Submission on METHODS OF CONSTRUCTION AND CONSTRUCTION SPACES

TEALING TO KINTORE UPGRADE PROJECT (TKUP) TRL-120-1

Fig. 1 Typical piled tower base

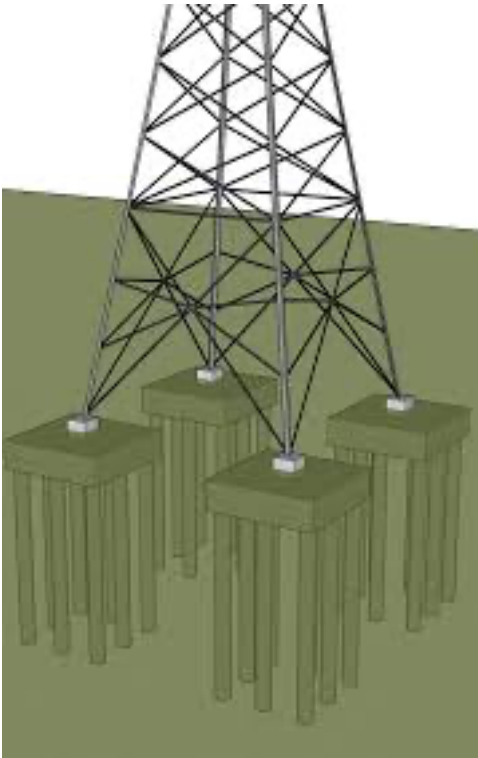
Piled foundations would be necessary where the soils are soft or the site is unsuitable for other types of foundation. Piling plant is generally noisy and vibrating by its nature. There are methods which are quieter than others, and the specific type of piling proposed along with locations is not provided.

Fig. 2 Typical rock anchor foundations

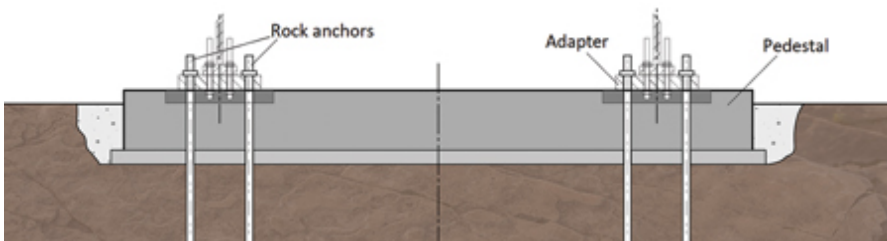
Where the bedrock is near the surface of the ground, the foundations may incorporate the installation of rock anchors. This operation is also noisy it will impact on the surrounding environment. Where rock is near the surface, there will be a requirement for considerable hydraulic rock breaking to provide a surface suitable for the installation of rock anchors, again a high noise impact. Blasting is not mentioned, and it is presumed use of explosives will be prohibited? It is envisaged that rock of various types will be encountered at a high level along the route.

Fig. 5 Illustrative image of Temporary Working Area (SEEN)

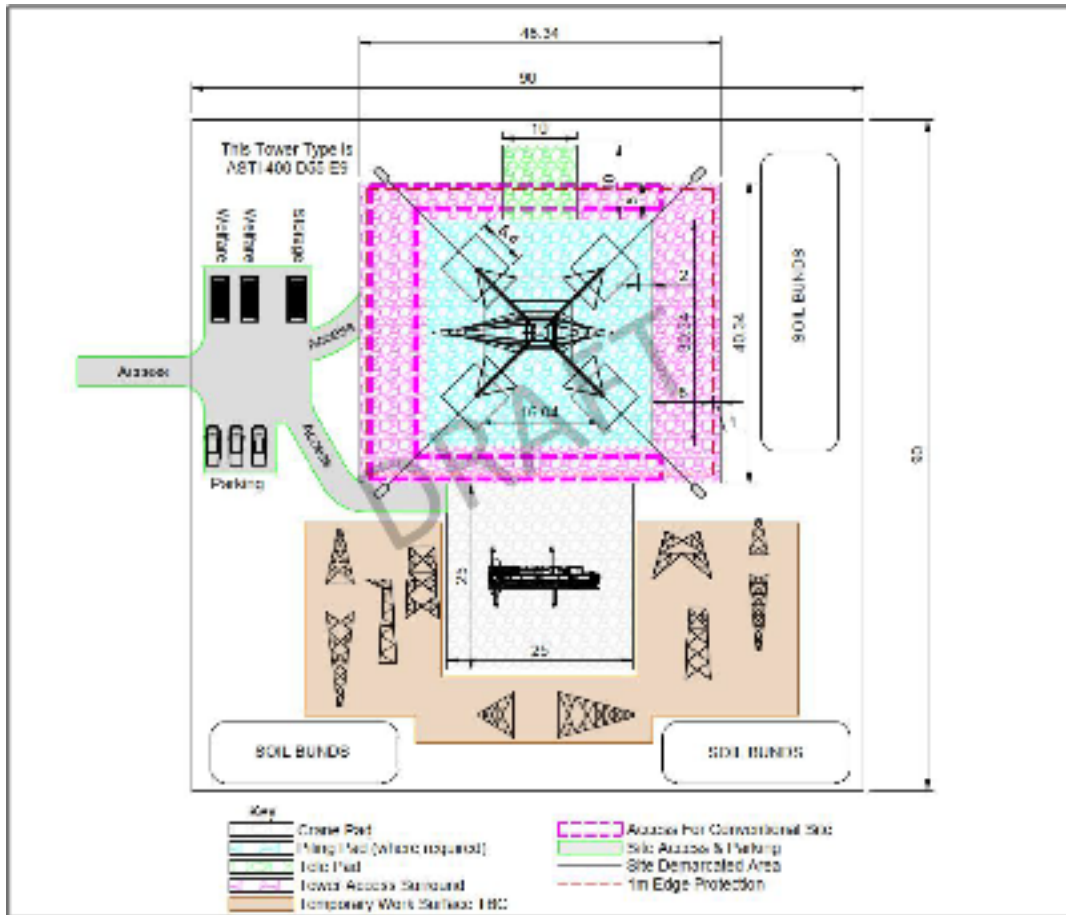
The 'temporary working areas' indicated occupy an area of 80 x 80m for linear towers and 100 x 100m for corner towers. These areas are large, and they will need to be flat in order to assemble and lay down the tower sections and to allow the mobile crane(s) to operate safely. If the existing ground slopes, earthworks increase dramatically, for example, if the existing ground slopes at 1 in 10, the working area will have a 5m cut height at the top and a 5m drop on the lower edge of the area. Access roads will need to be positioned to suit these slopes as will the topsoil and excavated material storage areas. The document does not consider this probability, and it is my opinion that the working areas are likely to be too small if column and pad foundations are adopted and all the excavated material and topsoil are stored on the working area.

Parts of the working area where the crane will be working and traversing will require a 'crane platform' which comprises engineered rockfill. This will be crushed rock which spread the loads from the outriggers of the crane into the underlying soils safely. Rockfill is compacted with vibratory equipment to a thickness of say, 500 to 1000mm.
